PROJECT  
ASIA  
DEVELOPMENT

DESIGN MEMORANDUM NO. 7.  
GENERAL DESIGN MEMORANDUM

SUBJECT: Snettisham Project, Alaska; Design Memorandum No. 7,  
General Design Memorandum

NPDEN-TE (13 Nov 65) 1st Ind  
SUBJECT: Snettisham Project, Alaska; Design Memorandum No. 7, General  
Design Memorandum

Q. 7, FIGURE 20 3

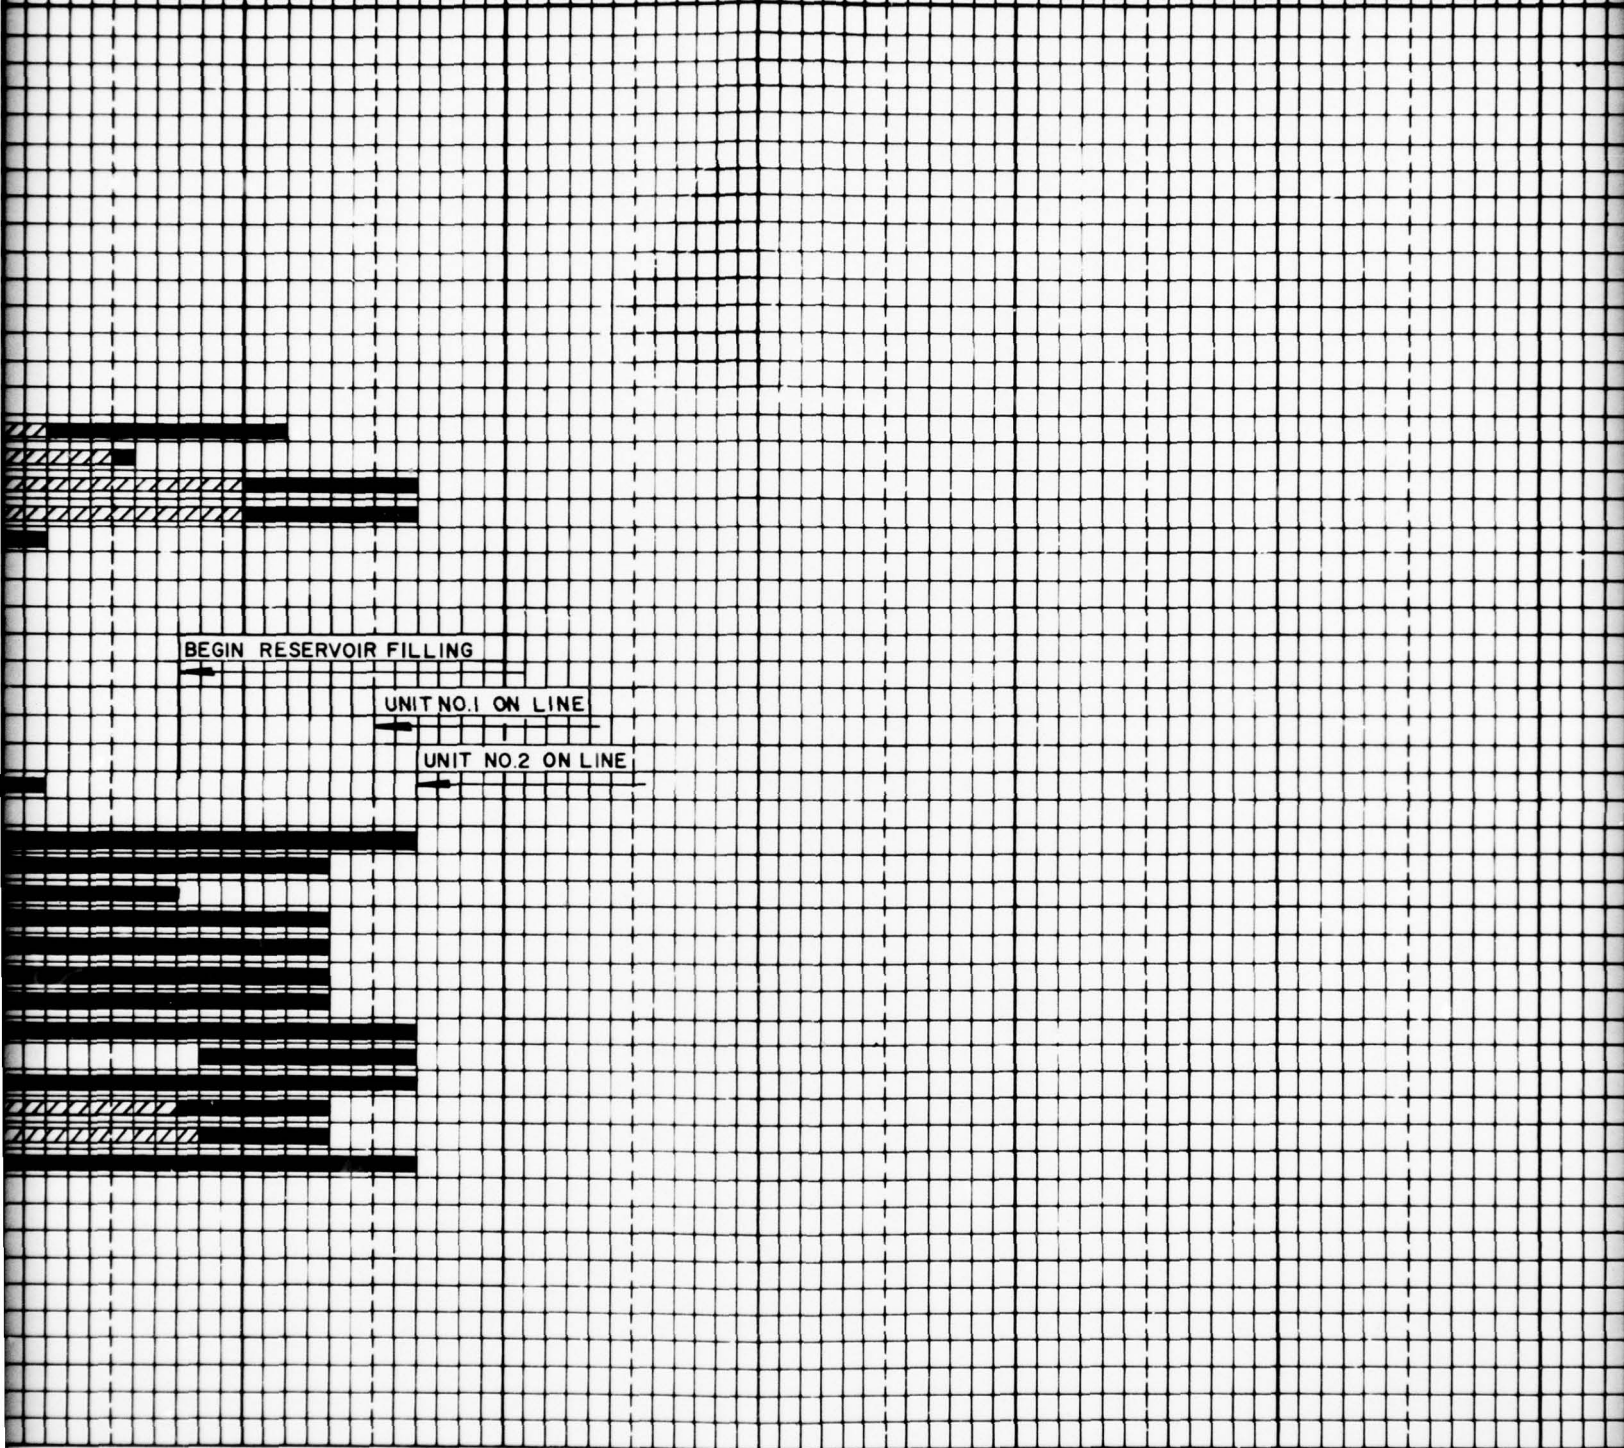
aa. Figure 20. Schedule is no longer applicable.
